Gist of Discussion during Interactive Session held on 01.05.2024 regarding Submission of Technical Connection Data for RE

Frequently faced issues (Submission of Technical Connection Data- RE)

Figure 1 Plant reactive power response during LVRT condition LVRT-0.85pu in PSS/E

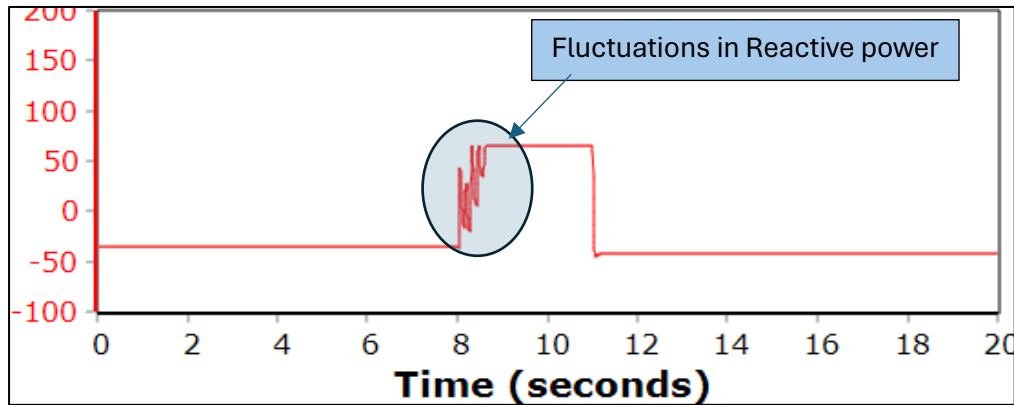
- Fluctuations in reactive power during LVRT conditions:

Figure 2 Plant reactive power response during VRT-1-0.95pu in PSS/E

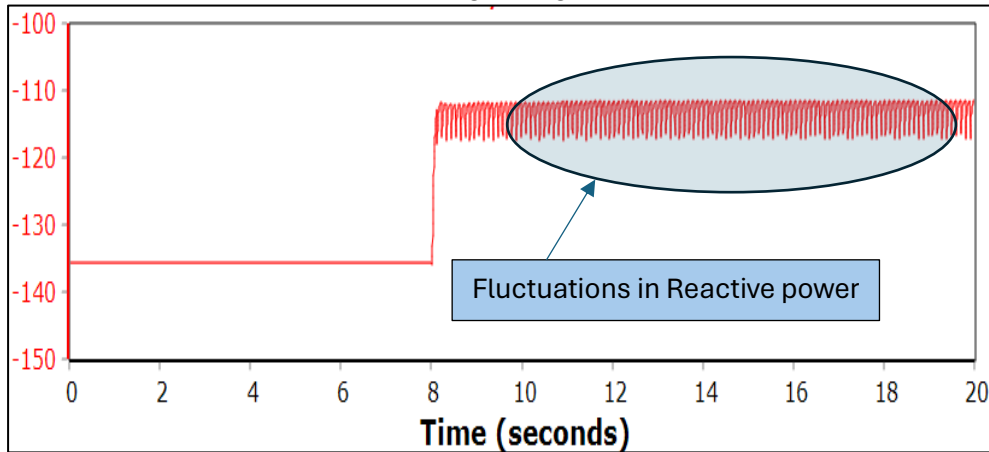
- Fluctuations in reactive power during voltage response test:

Figure 3 Plant active power response during HVRT (1.15pu case) in PSS/E

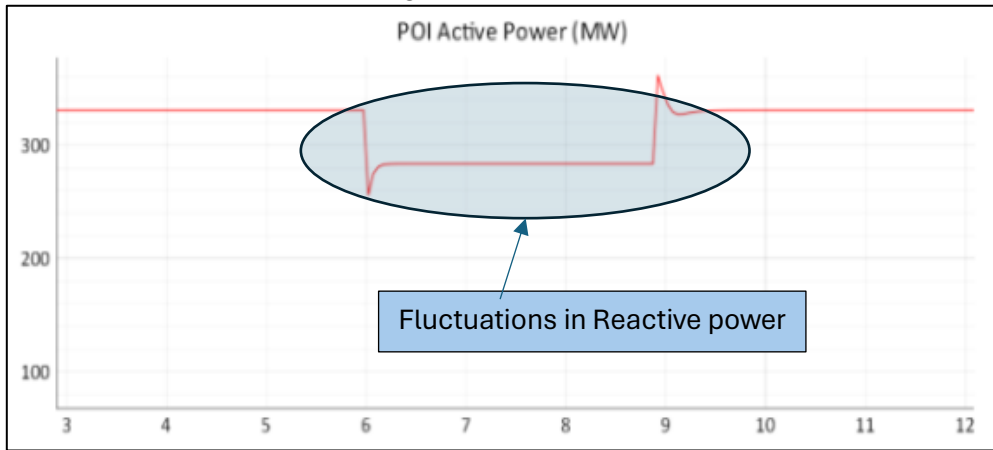
3. Reduction in active power during HVRT conditions:

Figure 4 Plant active power response during LVRT (0.15pu case) PSS/E

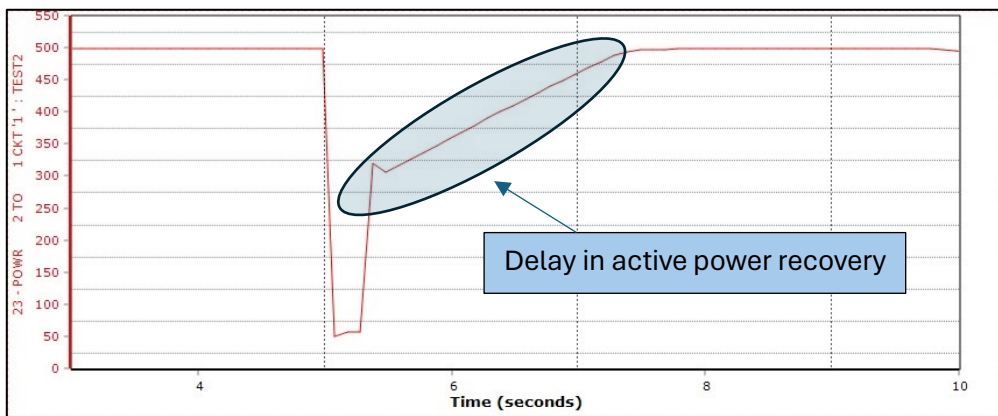
4. Delay in active power recovery during LVRT conditions:
